- A. Preliminary Plat (SUB-2022-0007), "Symphony Ridge Ph. 3" proposing to subdivide 11.93 acres into 17 lots and 1 tract generally located on W. 28th Avenue. The site is currently zoned Residential, Low Density (RL), the Comprehensive Plan designation is Low Density Residential. The applicant is Scot Bauder, Bauder Construction, 8708 S. Toro Place, Kennewick, WA 99338, and property owner is Scot & Tyler LLC, 2453 Morency Drive, Richland, WA 99352.
- B. Planned Residential Development (PRD-2022-0000), "Zintel Way Apartments" a 195-unit apartment complex with 5 additional single-family lots. The site is generally located at 4303 S. Zintel Way. The site is currently zoned Residential, Medium Density (RM), the Comprehensive Plan designation is Medium Density Residential (MDR). The applicant and owner is Evergreen Housing Development Group LLC, PO Box 24787, Seattle, WA 98124.

STAFF REPORT AND RECOMMENDATION TO THE HEARING EXAMINER

FILE No: SUB-2022-0007

PRELIMINARY PLAT OF
SYMPHONY RIDGE

Exhibit 2

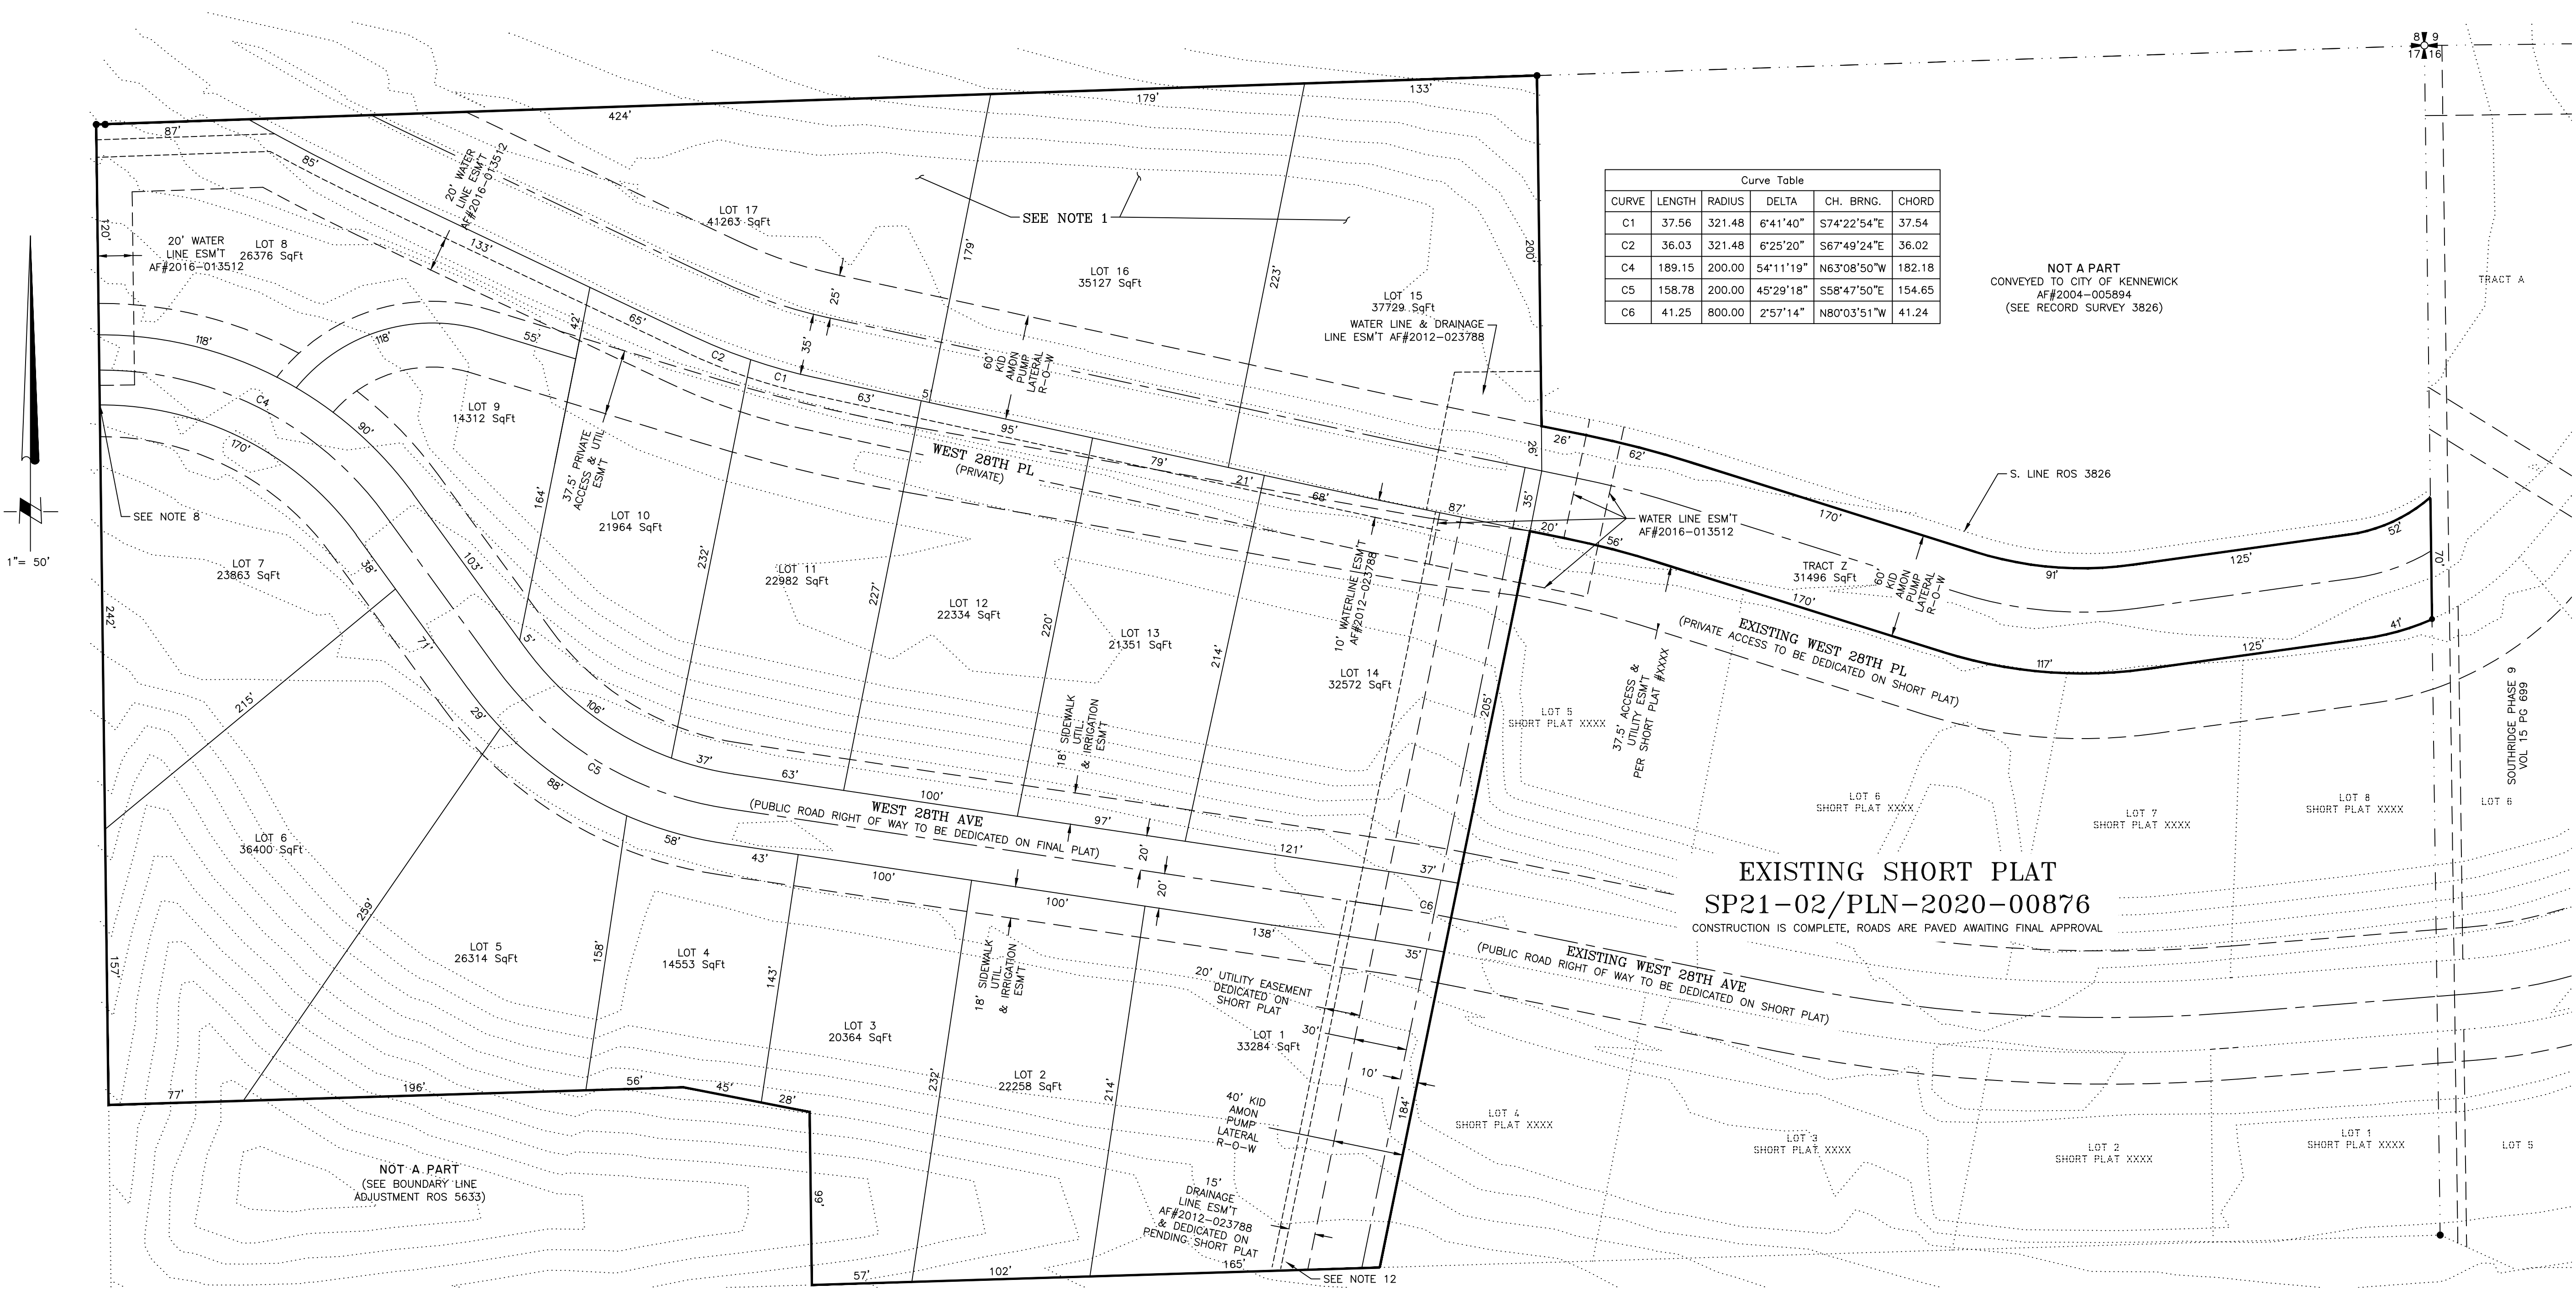
The applicant proposed access to Lots 15-17 via W 28th Place. The Kennewick Irrigation District will need to grant access onto its easement so Lots 15-17 can access W 28th Place. As proposed, Lots 15-17 do not have frontage onto W 28th Place, the lot lines between Lots 10-17 will have to be adjusted so street frontage can be established for Lots 15-17.

Additionally, the Kennewick Irrigation District must grant access across its easement and the applicant must establish street frontage on W 28th Place prior to final plat submittal, so Lots 15-17 may remain as separate lots. Lots 15-17 must have the required access or they will have to be combined into either Lot 8 or Tract Z.

4. All fees required by the City shall be paid prior to approval of the final plat.
5. Street frontage and access to W 28th for Lots 15-17 shall be established on the plat prior to Final Plat submittal.

Exhibit 7

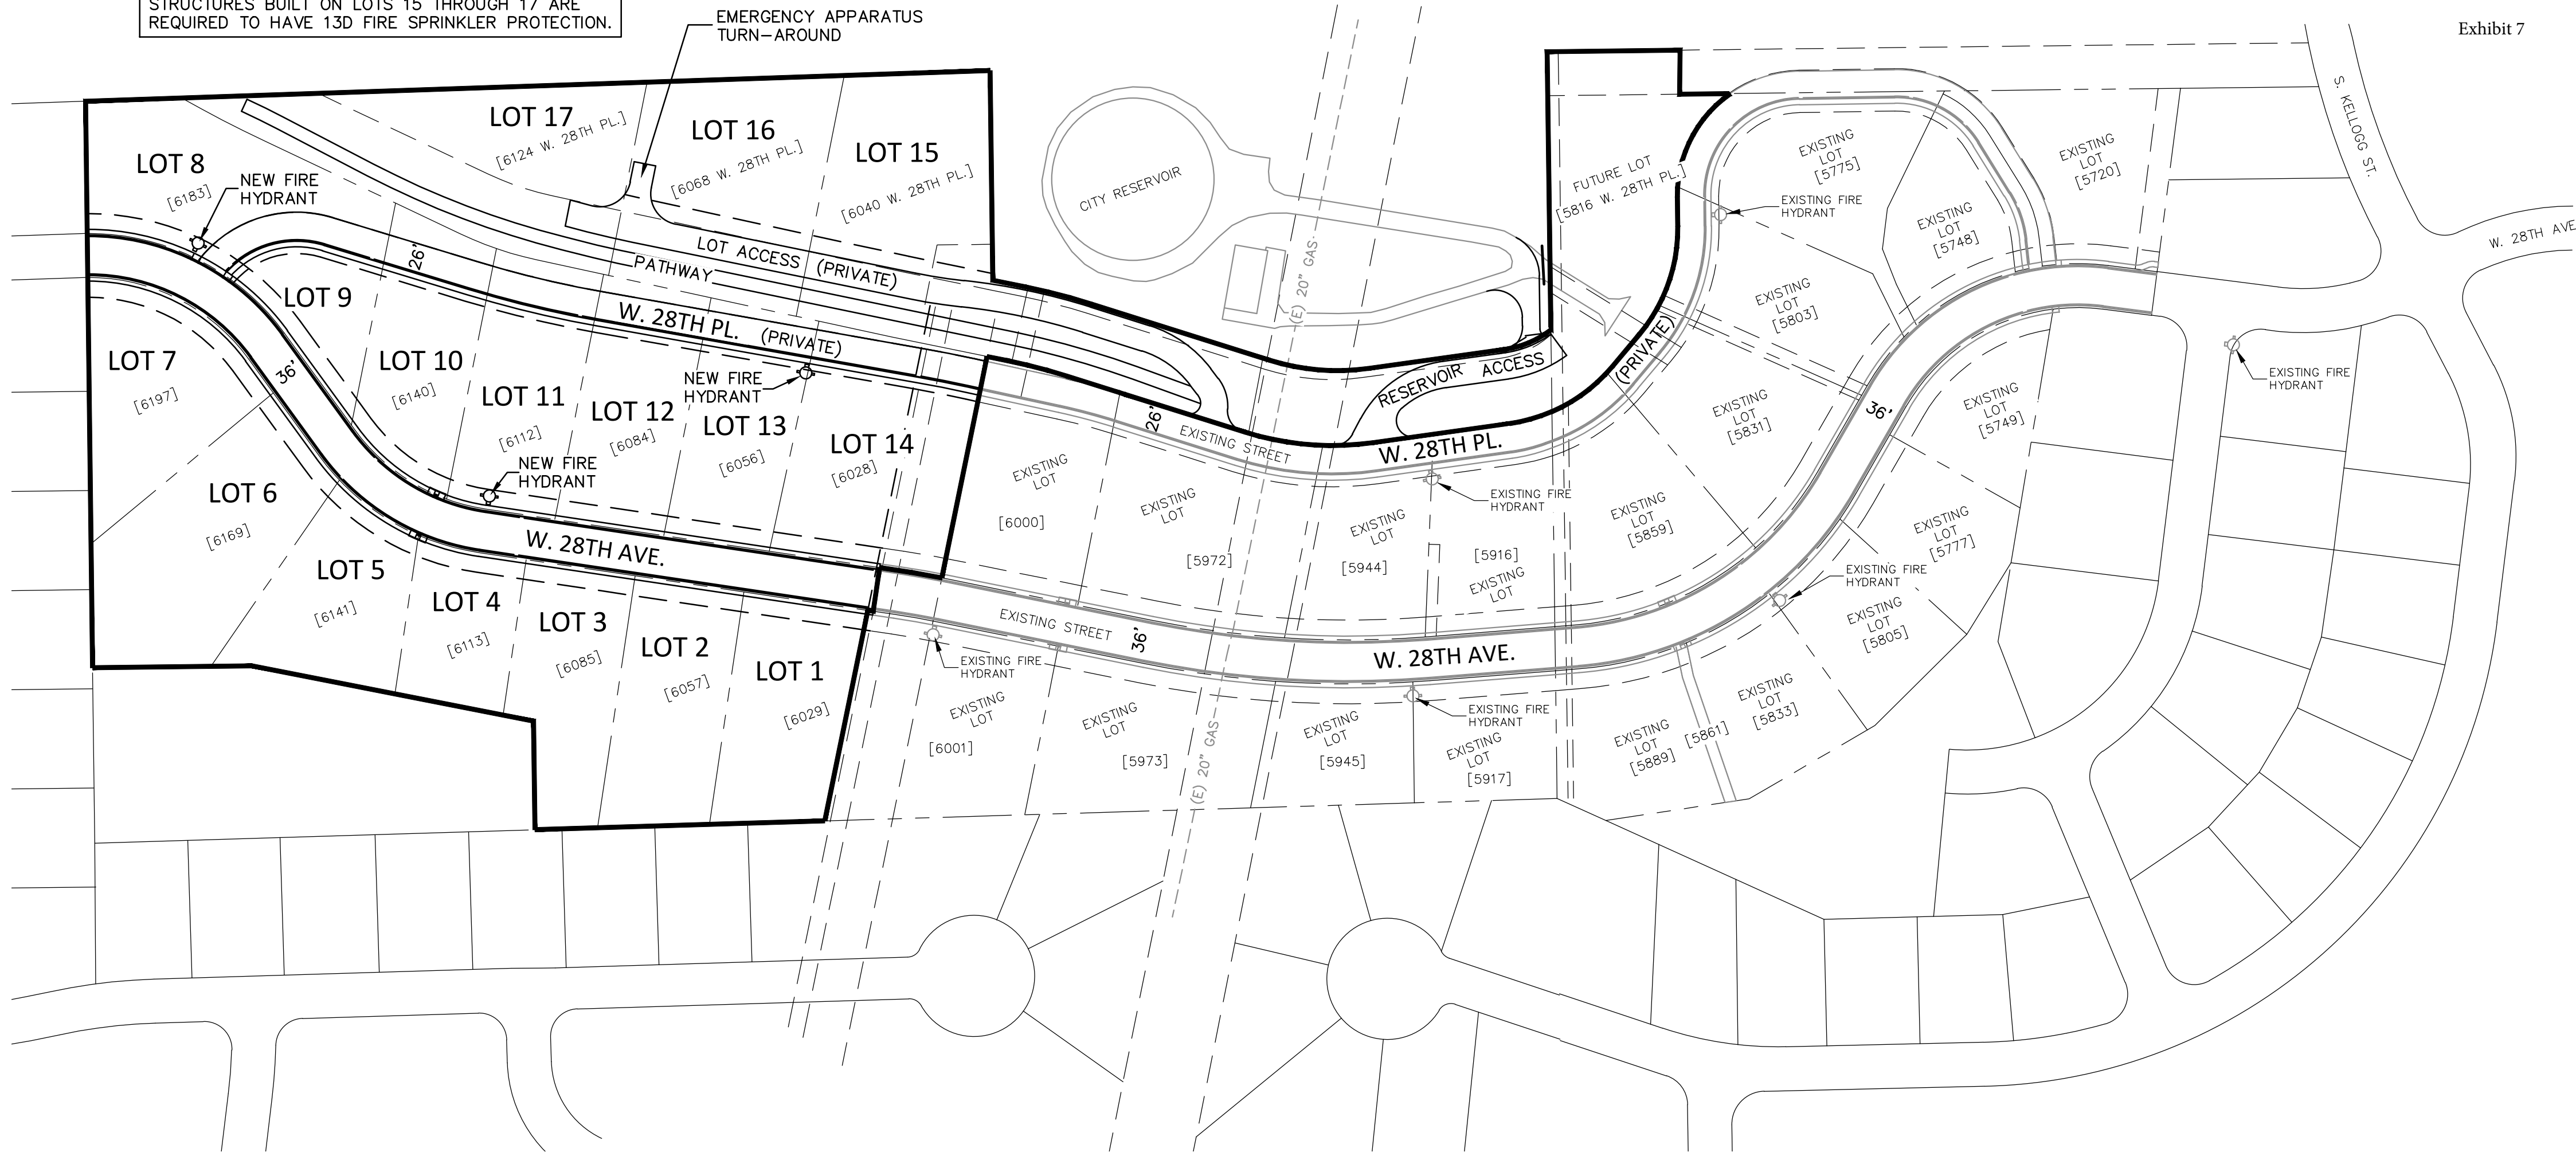
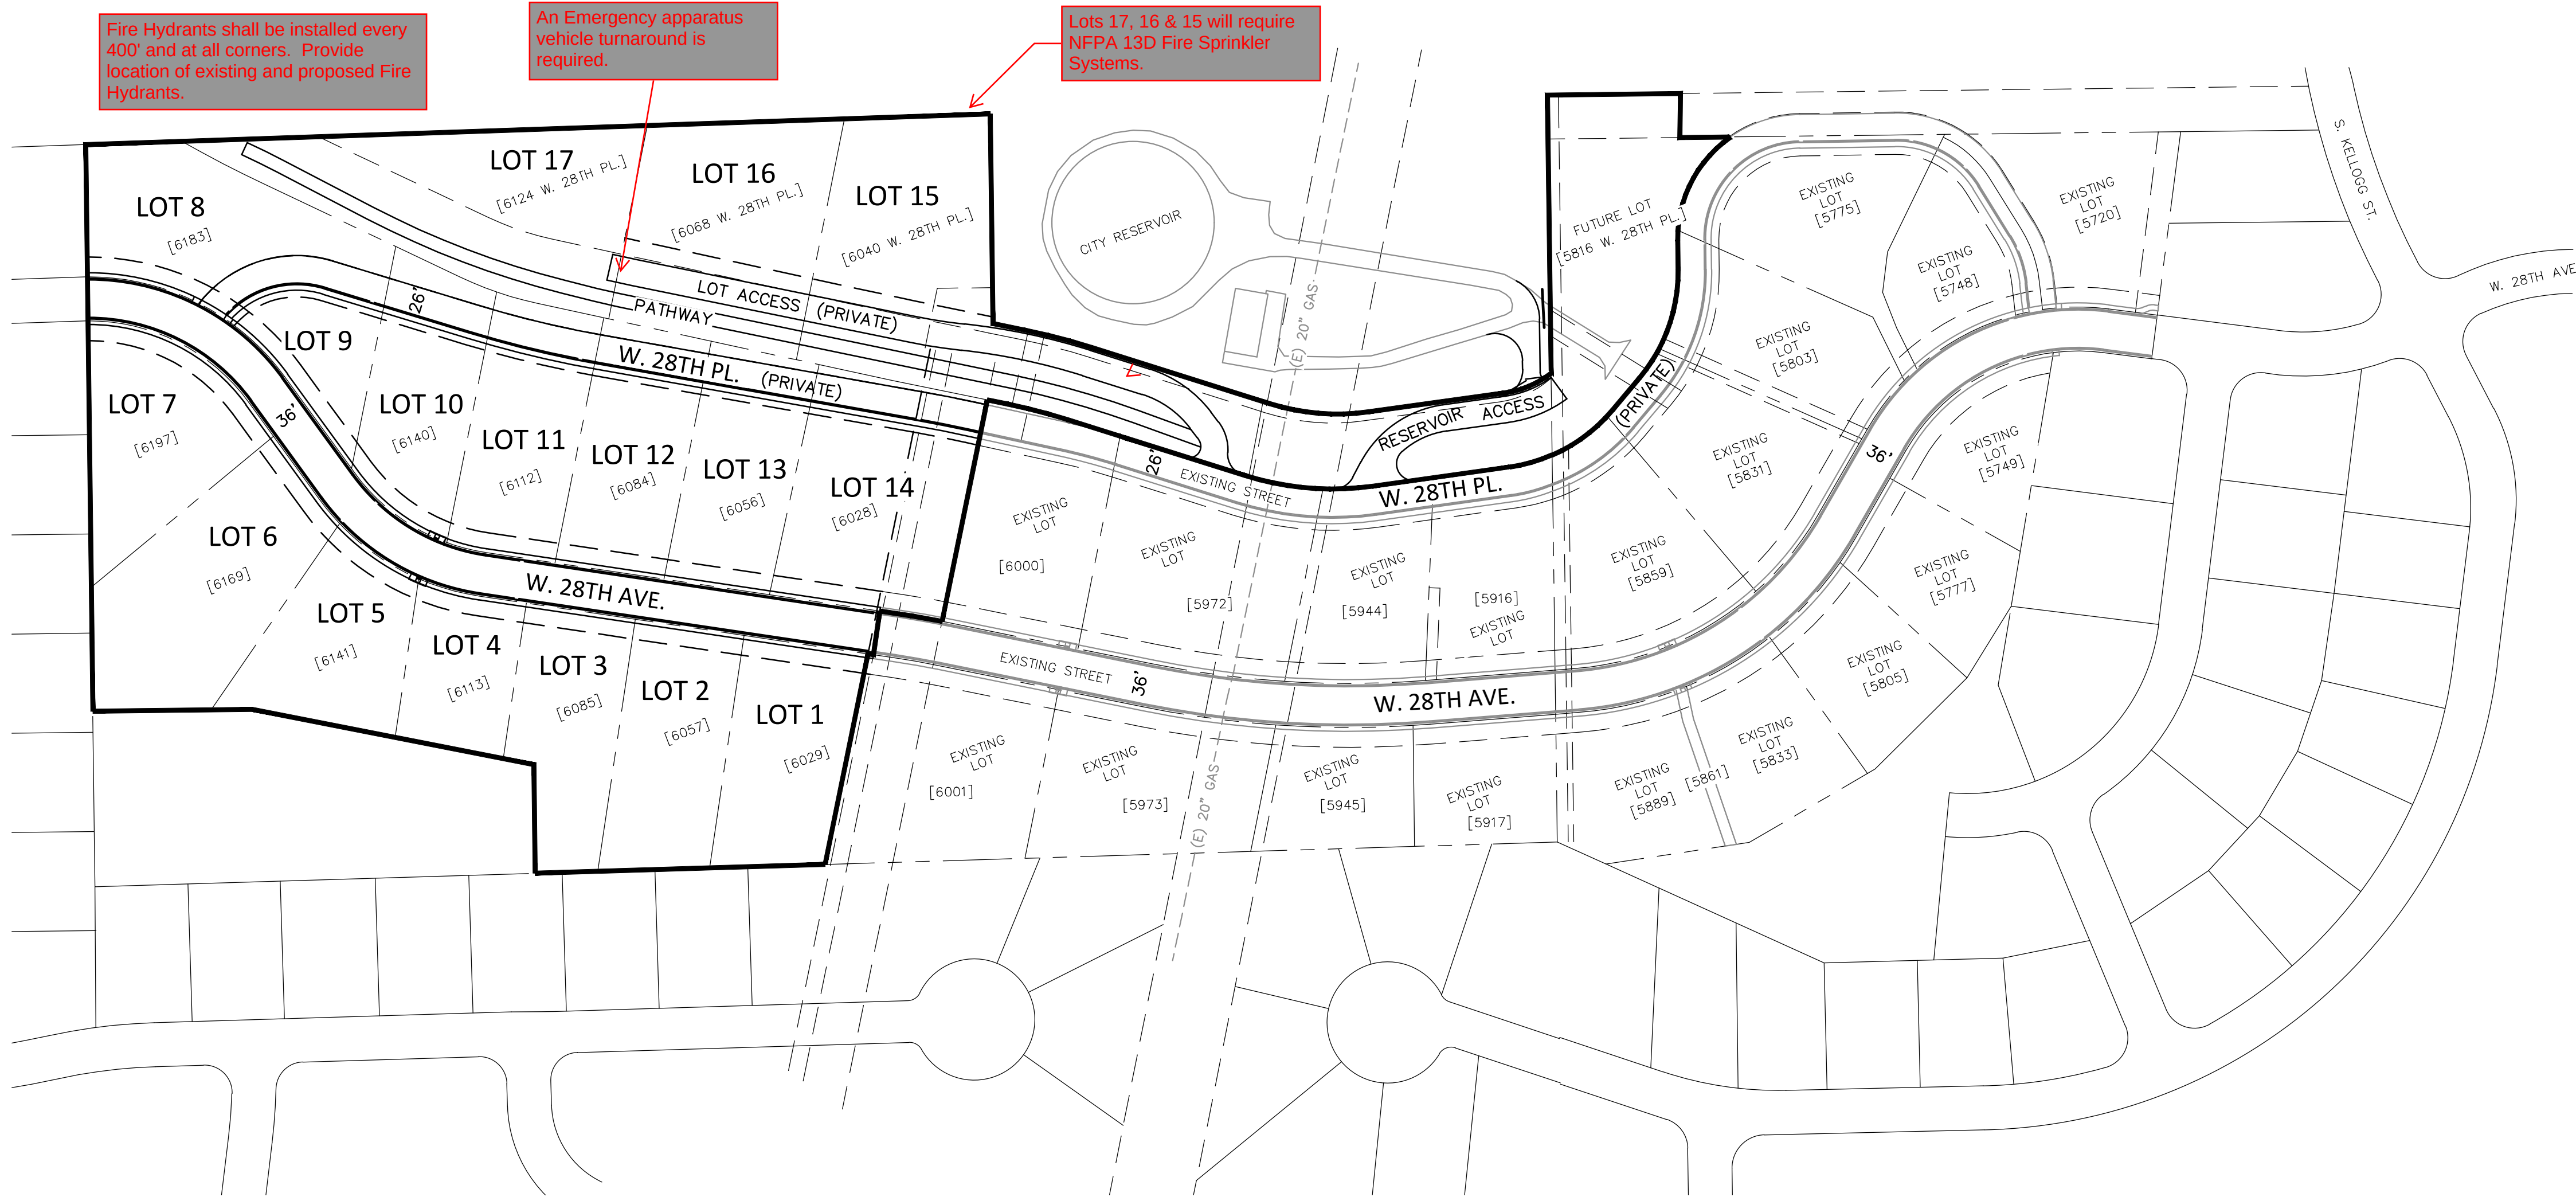
Fire hydrants shall be installed every 400' and at all corners. Provide location of existing and proposed fire hydrants. **See attached display.**

Lots 15, 16 & 17 will require NFPA 13D fire sprinkler systems. **This will be included on the street & utility construction plans and noted on the final plat.**

A permanent paved access to the reservoir must be provided for review showing a max. grade of 12% and horizontal curve supporting the Fire Department and Public Works vacuum equipment. This access shall be a minimum of 6 inches of top course rock and 2 inches of asphalt meeting standards for typical residential street. **Included in the street & utility construction plans will be a paved access meeting these requirements.**

Any new streets shall meet the latest version of hillside development or request a variance by showing how it can closely meet those requirements. Include utilities, services, hydrants, street lights and no parking on the north side of the street. **These comments are understood. We will work with City staff to meet requirements and provide continuity of the roadways and meet City standards.**

STRUCTURES BUILT ON LOTS 15 THROUGH 17 ARE
REQUIRED TO HAVE 13D FIRE SPRINKLER PROTECTION.

EMERGENCY APPARATUS
TURN-AROUND
